# UNITED STATES PATENT AND TRADEMARK OFFICE

APPLICATION NO.	FILING DATE	FIRST NAMED INVENTOR	ATTORNEY DOCKET NO.	CONFIRMATION NO.
10/520,579	10/03/2005	Peter D Hood	17638-005US1	5951

<b>Office Action Summary</b>	<b>Application No.</b> 10/520,579	<b>Applicant(s)</b> HOOD ET AL.	
	<b>Examiner</b> EUGENIA WANG	<b>Art Unit</b> 1795

## **DETAILED ACTION**

FIG.3

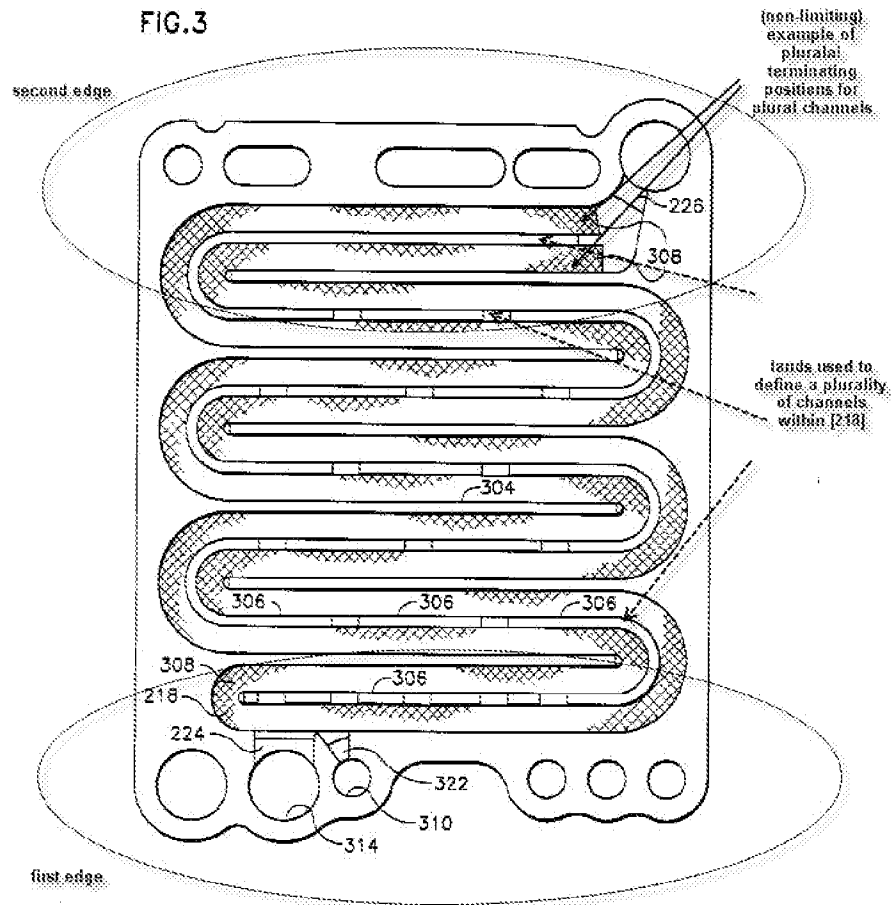
lines 59-63). As seen in fig. 2C, portions of the channel of cooler-humidifier plate [202] extends across the plate. "At a first edge" (see 112 rejection for interpretation as to what constitutes "at") can be interpreted to be the inlet portions, such as inlet manifold hole [314] and water inlet hole [310] as well as upper portions of the channel [218] (see fig. 3). "At a second edge" (see 112 rejection for interpretation as to what constitutes "at") can be interpreted to be the outlet portions, such as gas outlet [226] and lower portions of channel [218] (see fig. 3). Accordingly, the channels can be said to terminate at different positions (as indicated by the wicks and lands of fig. 3), wherein it can be seen in fig. 2C that the channels of the cooler-humidifier plate [202] are coincident with those of the cathode flow plate [216]. It is noted that outlet [226] bridges the termination of the channels (end portion of channel [218]) as well as provides direct fluid communication with a respective field plate channel (as it provides cathode gas water via manifold [256]) (fig. 2C; col. 7, lines 20-31). This constitutes a water injection point that enables delivery of water directly into corresponding field plate channel. The embodied material for the cooler-humidifier plate [202] is stainless steel (thus qualifying it to be considered a foil) (col. 6; lines 33-35). See annotated figure below for clarification as to the interpretation taken with respect to the distribution foil (cooler-humidifier plate [202]).

It is noted that the cathode plate [216] is seen to be a cover extending over the distribution foil (humidifier plate [202] to enclose the channels and form conduits for water between the them, as Vitale et al. teach that plate [216] serves the purpose of closing open-face flow channels [218] of the cooler-humidifier plate [202], wherein the wick of the coolant-humidifier plate [202] provides water to the reactant gas (col. 6, lines 44-46; col. 7, lines 64-65; fig. 3).

As to claim 3, Vitale et al. teach that the channels (portion of channel [218] close to outlet [226]) terminates at a second edge. (See annotated figure in the rejection to claim 1 as to the interpretation taken. See also the 112 section as the interpretation taken with respect to the first and second edge in light of the 112 issues.) As seen in fig. 2C, outlet [226] can be seen to be a convergence structure, as it focuses water flow into the channels [210] in the fluid flow plate of fluid flow (as humid air exits through outlet [226]) (col. 7, lines 26-30).

As to claim 4, Vitale et al.'s convergence structure (gas outlet [226]) shows a recess on the second edge of the distribution foil (plate [202]), as gas outlet [226] is cut out (fig. 3).

As to claim 5, Vitale et al.'s cut out (gas outlet [226]) can be considered to be arcuate, as at least one portion of the cut out is curved.

Examiner respectfully disagrees. It is noted that there are different "terminating" points of Vitale et al. (as defined by the lands set forth within channel [218]), wherein a place of convergence ([226]) is provided afterwards. (See annotated fig. in claim 3 in the rejection to claim 1 for details as to the interpretation taken.) It is noted that there is nothing within the claim barring such a claim interpretation. Furthermore, such a claim interpretation is made in light of the numerous 112 issues set forth above. Office personnel are to give claims their broadest reasonable interpretation in light of the supporting disclosure. *In re Morris*, 127 F.3d 1048, 1054-55, 44 USPQ2d 1023, 1027-28 (Fed. Cir. 1997). Also, limitations appearing in the specification but not recited in the claim are not read into the claim. See *In re Zletz*, 893F.2d 319, 321-22, 13 USPQ2d, 1320, 1322 (Fed. Cir. 1989). In such a manner, direct fluid communication (as claimed) is still achieved (through [226]). Additionally, it is noted that Jones et al. has also been relied upon to render obvious the teaching of a plurality of water injection points (due to the fact that Vitale et al. does only have one injection point [226]). (See rejection to claim 1 for full details.) Accordingly, it is submitted that the claimed features are
